# Route 5/Virginia Capital Trail

## Pedestrian Safety and Operational Assessment

### Henrico County, Virginia

**July 8, 2016**

# STEEP GRADE WITH SHARP CURVES, ETC.

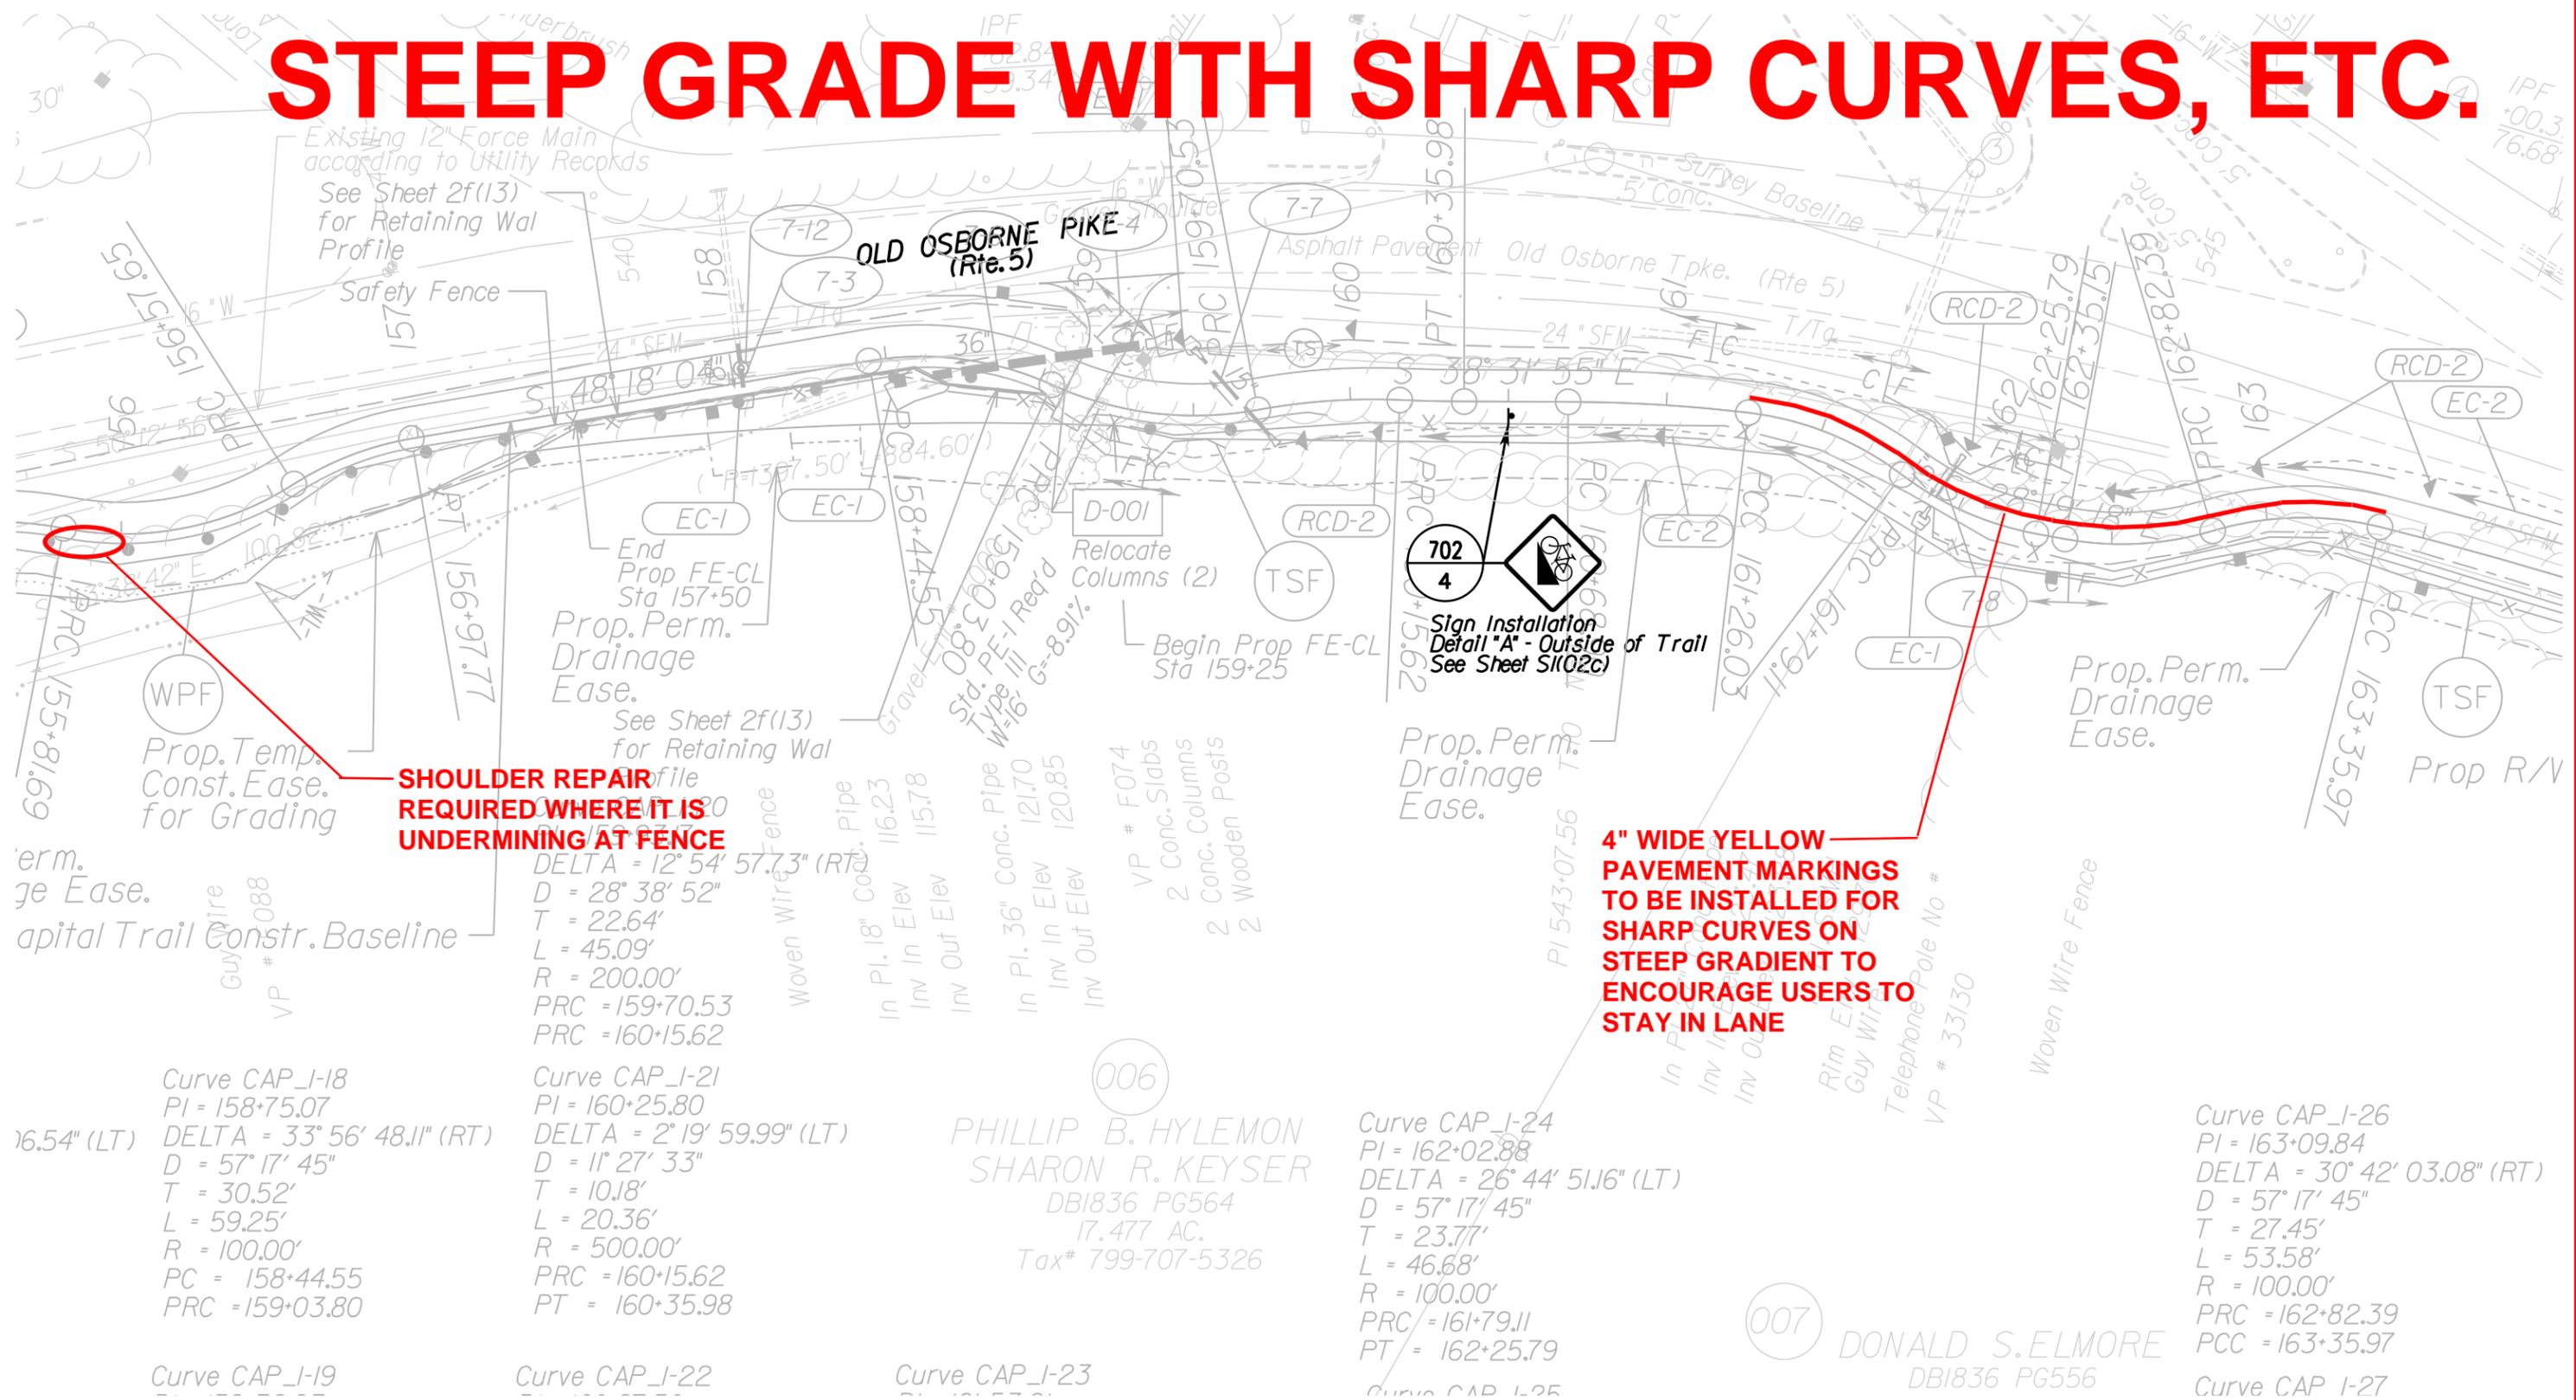
**SHOULDER REPAIR  
REQUIRED WHERE IT IS  
UNDERMINING AT FENCE**

**4" WIDE YELLOW  
PAVEMENT MARKINGS  
TO BE INSTALLED FOR  
SHARP CURVES ON  
STEEP GRADIENT TO  
ENCOURAGE USERS TO  
STAY IN LANE**

# NEW MARKET VETERINARY AREA

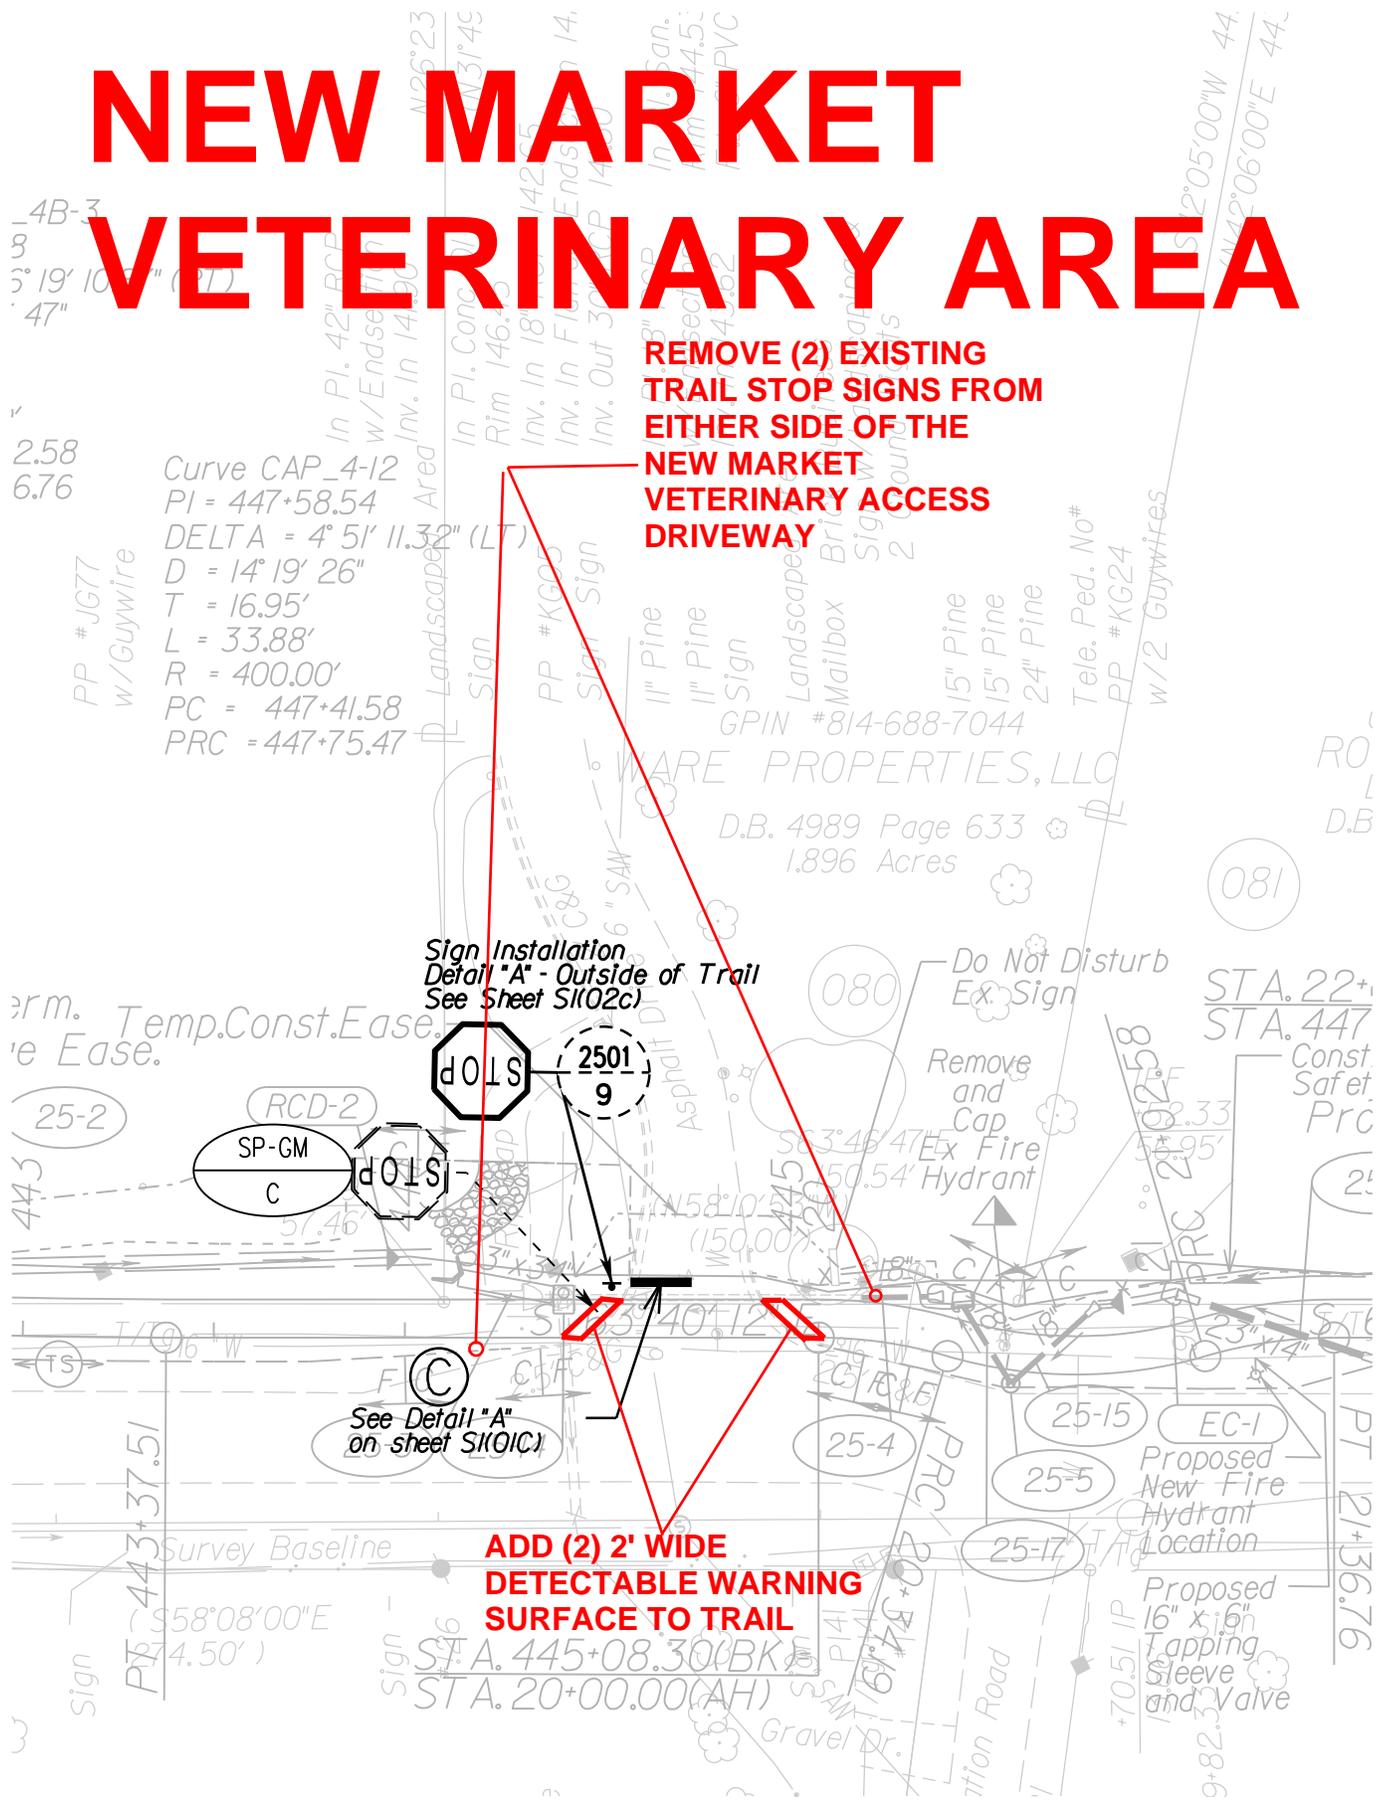
**REMOVE (2) EXISTING  
TRAIL STOP SIGNS FROM  
EITHER SIDE OF THE  
NEW MARKET  
VETERINARY ACCESS  
DRIVEWAY**

**ADD (2) 2' WIDE  
DETECTABLE WARNING  
SURFACE TO TRAIL**

# GREGG ROAD AREA

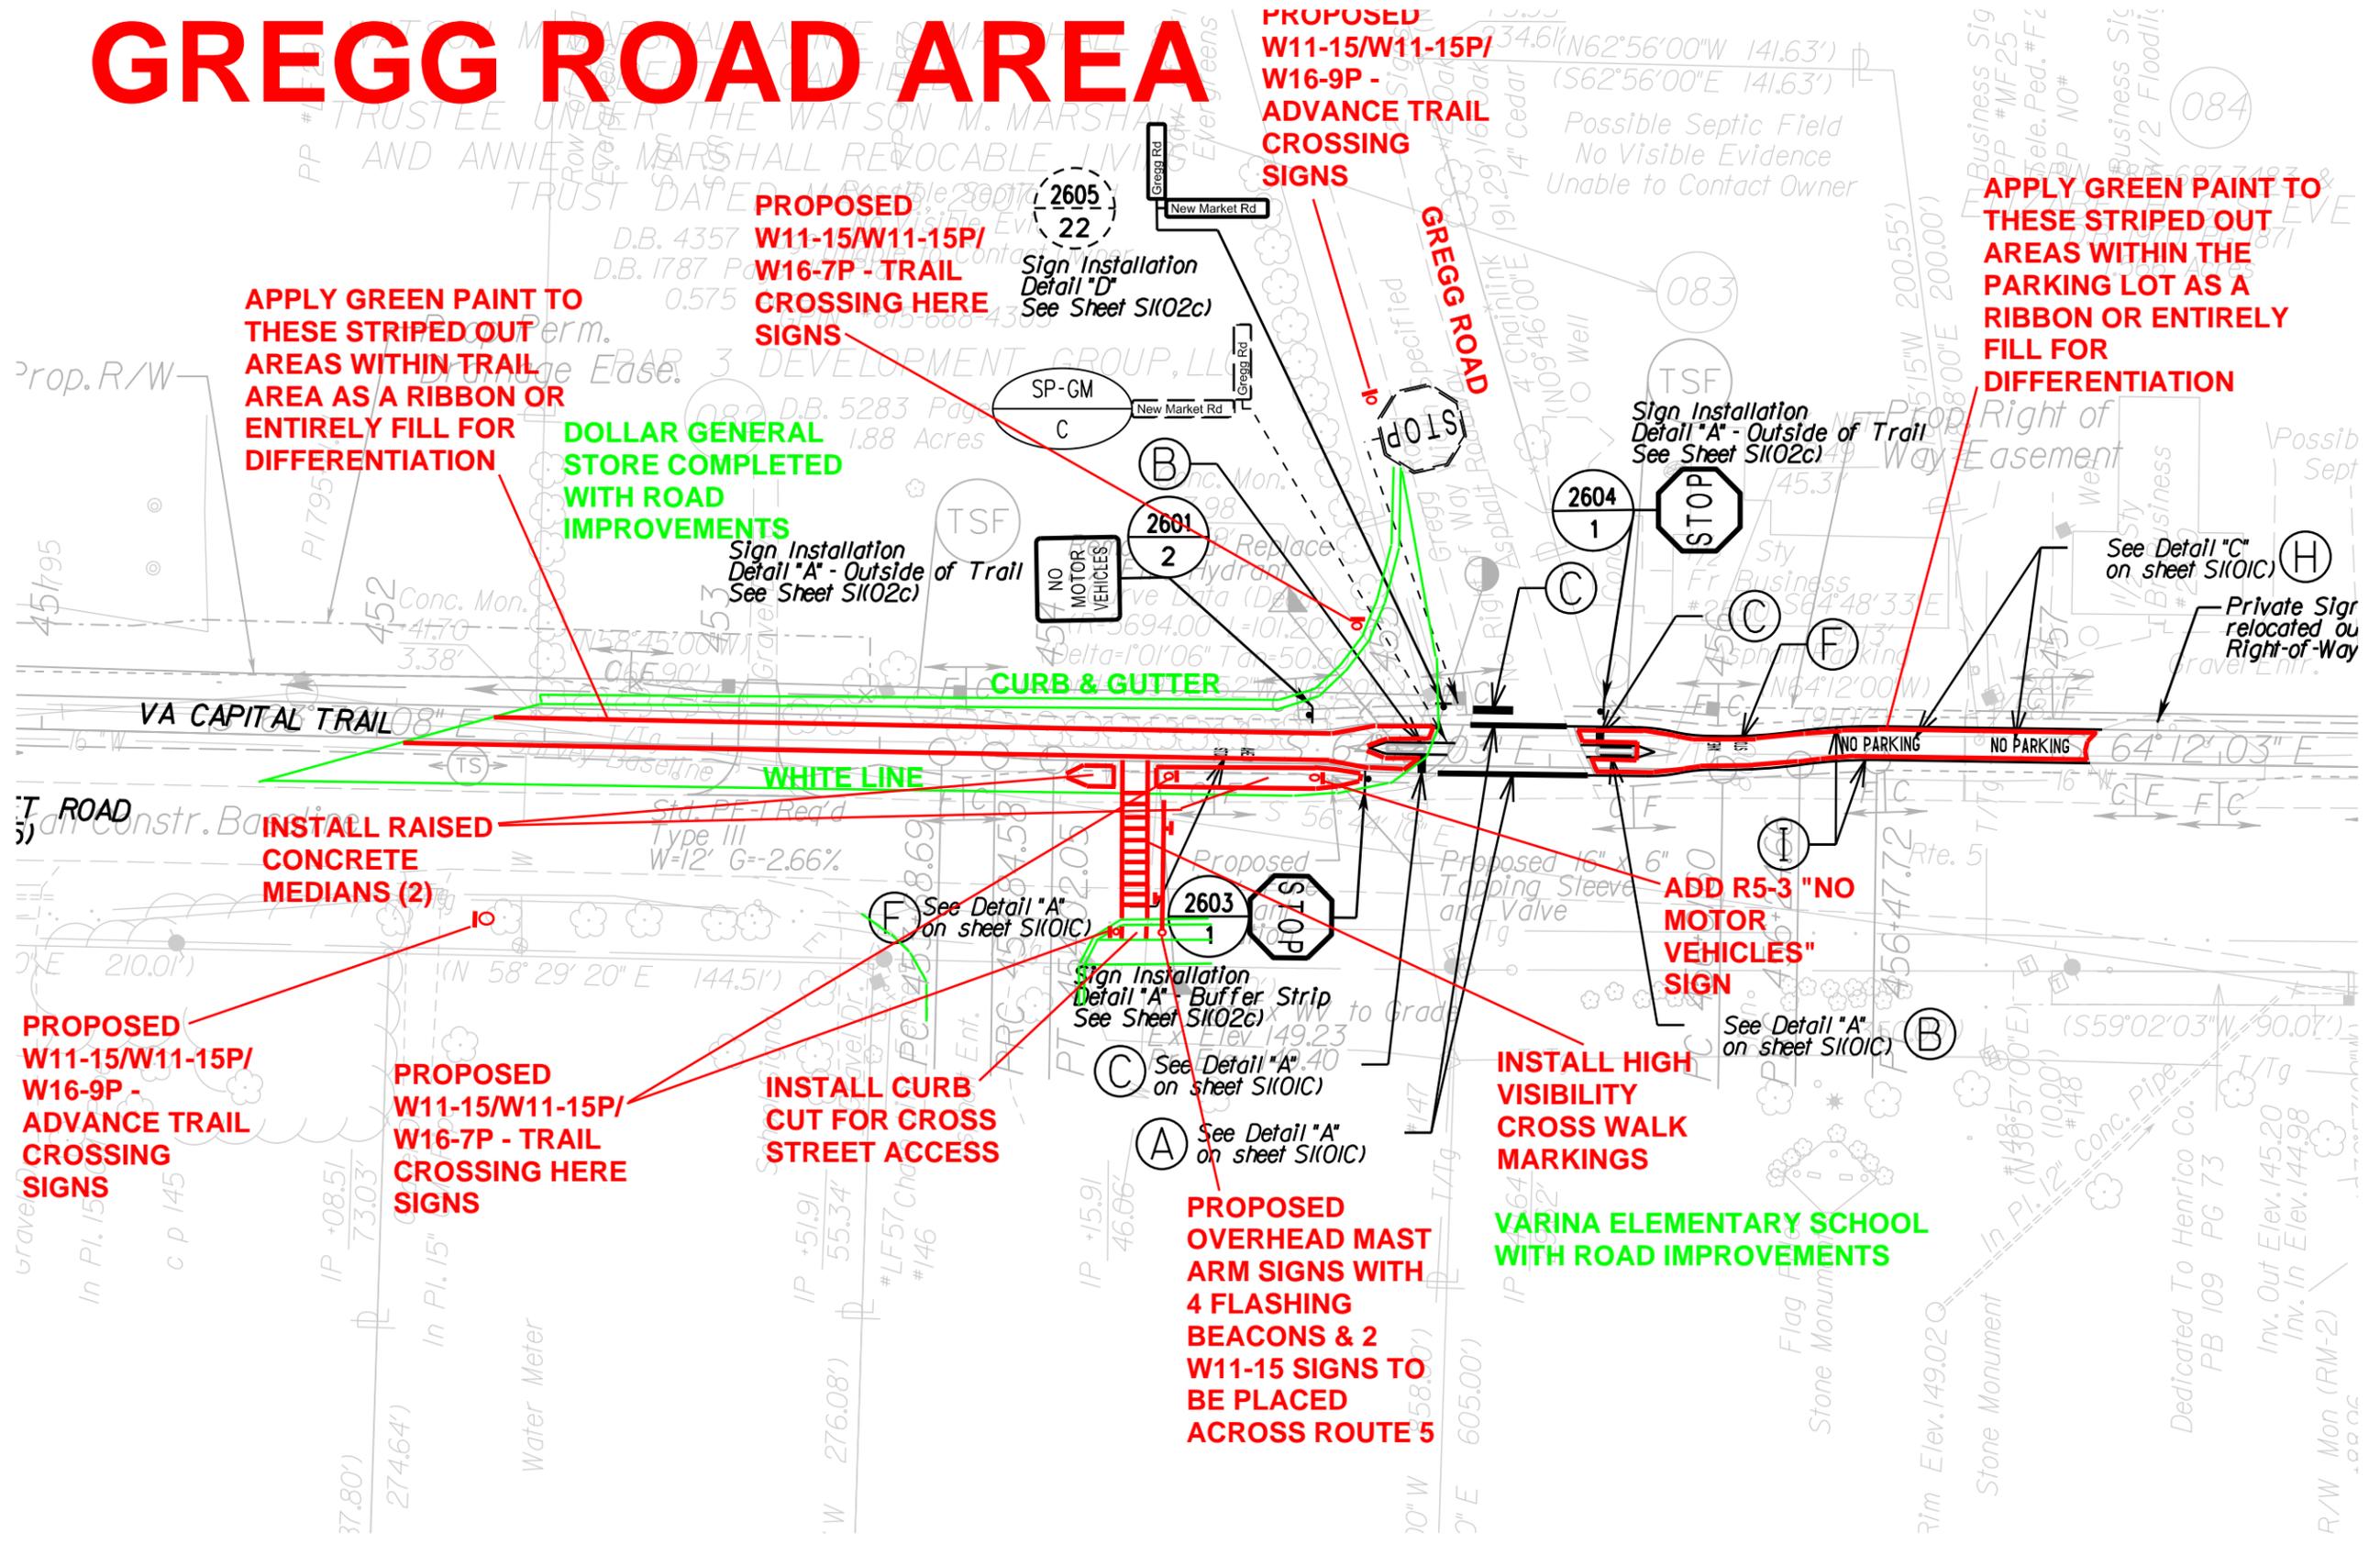
APPLY GREEN PAINT TO THESE STRIPED OUT AREAS WITHIN TRAIL AREA AS A RIBBON OR ENTIRELY FILL FOR DIFFERENTIATION

ADD R5-3 "NO MOTOR VEHICLES" SIGN
